### IMPORTANT SAFETY NOTICE

**SUBJECT: RIDGID® ProPress XL and R2 Press Rings, sizes 2½", 3" and 4", sold individually and as a part of kits through August 10, 2007:**

August 31, 2007

**Ring with Strap –**  
(Correct No Action Required)

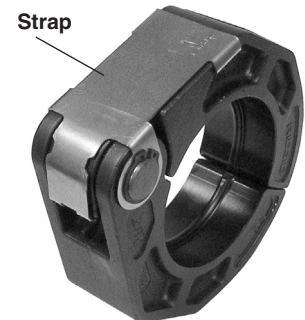
**This is a Product Recall Notice.** Ridge Tool recently determined that the hinge area of some of these rings could break and allow part of the ring to strike a user or others which could result in **serious personal injury**.

**All of the above listed products sold before August 10, 2007 may exhibit this problem.** Affected units can be identified by the catalog number on the packaging, and by the words "ProPress" or "R2" on the ring as shown in the above photos. Any ring sold after August 10, 2007 includes the strap shown, and is not subject to this recall. This recall does not apply to rings marked "ProPress XL-C"

Please take immediate steps to determine if you have any of these products in your possession. Do not use these rings until they have been retrofitted. Contact Ridge Tool Technical Services at (800) 519-3456 or [TechServices@ridgid.com](mailto:TechServices@ridgid.com). Ridge Tool will provide parts and instructions to retrofit the rings to prevent separation in the event that the hinge area breaks.
